Office Action Summary

10/033,387

LEVITSKY ET AL.

- 1) ☒ Responsive to communication(s) filed on 27 February 2004.
- 2a) ☒ This action is **FINAL**. 2b) ☐ This action is non-final.
- 3) ☐ Since this application is in condition for allowance except for formal matters, prosecution as to the merits is closed in accordance with the practice under *Ex parte Quayle*, 1935 C.D. 11, 453 O.G. 213.

FIG. 1

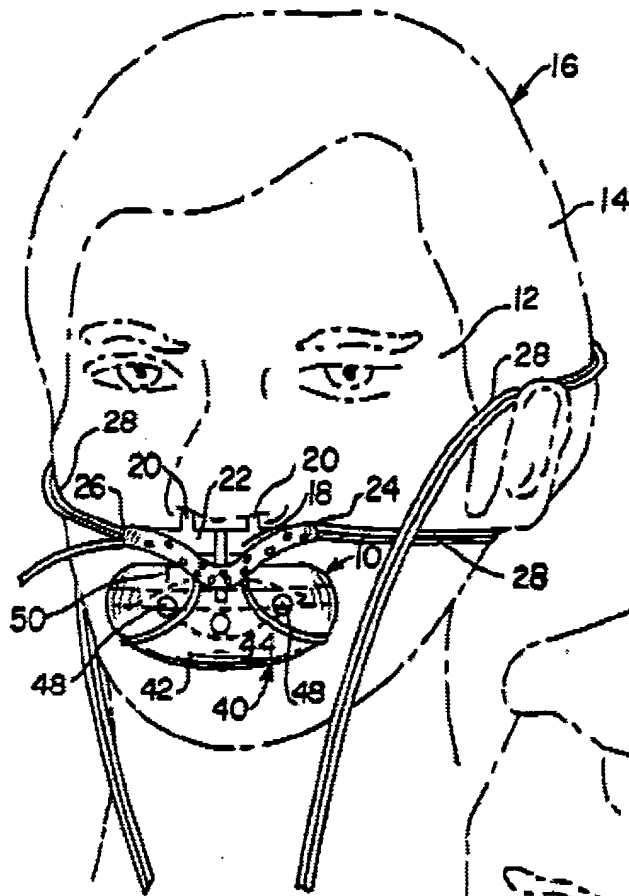
with the two ends of cannula 24 and 26. As shown in fig.1 and 2, an unidentified tube connected to the end of the v-shaped member must be connected to the inhalant gases source. The ends of oral gas conduits 68 either go through part of the v-shaped member, exit therefrom and connect to ends of the tubular member 60 or go behind the v-shaped member and connect to ends of the tube 60 for collecting oral exhaled gases. No septum is disclosed with respect to the cannula of fig. 3 like element 90 which is found in fig. 4 whereby gas is delivered to only one of the nares. Therefore, in fig. 3, exhaled nasal gases are delivered through both nares and are received by ends of the nasal exhaled gas conduits 28; and exhaled oral gases are received through holes 62 in tube 60 and are received by ends of the oral exhaled gas conduits 68. Inhalant gases are delivered through unnumbered tube into the left side of v-shaped tube and are delivered to the area between the nose and mouth of the user by being expelled through the apertures in the v-shaped tube. At least claims 2-6 of Derrick support this characterization of fig. 23 of Derrick.

FIG. 3

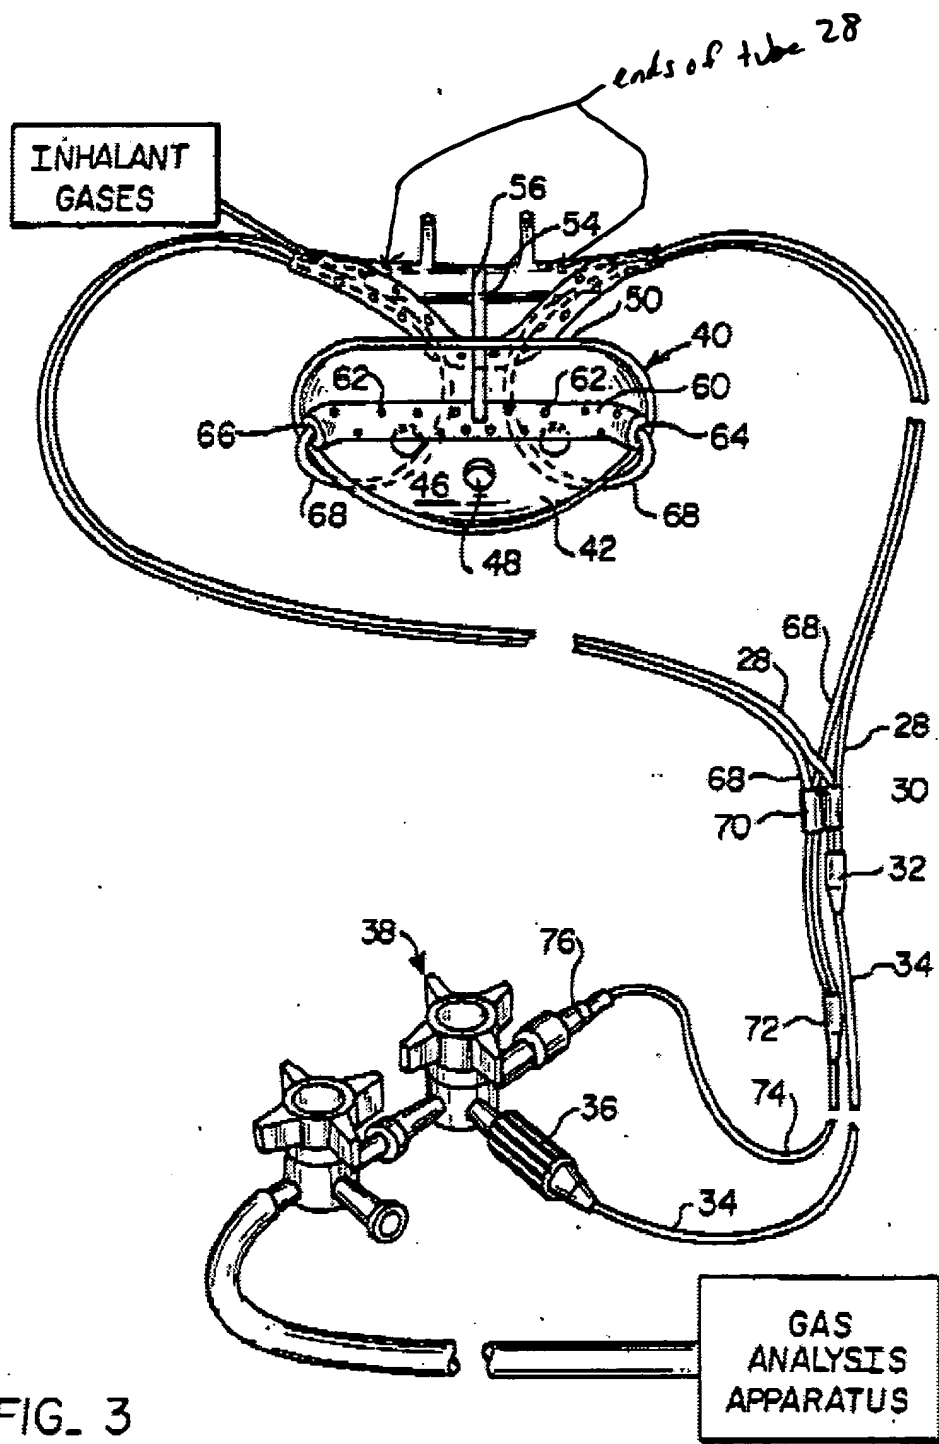
Derrick discloses a device and method of use including a cannula having a tube 68 for capturing oral exhalation gases, a tube 28 for capturing nasal exhaled gases and a porous tube in the shape of a v as shown in fig. 3 connected to inhalant gases which delivers gases to a region between the nose and mouth of the user, and a tube having nares for introduction into the nostrils of the user and connected to tubes 28 for capturing and delivering the nasal exhaled air to the gas analysis apparatus. .

The examiner respectfully disagrees with applicant's characterization of the fig. 3 embodiment of Derrick. Cannula 18 has two end portions 24,26 open to permit fluid communication with a pair of nasal exhaled gas conduits 28. The examiner believes that the outline tube at the top edge of the cannula (actually the top edge of both sides of the cannula have a tube outline) is indeed the ends of the two conduits 28 communicating
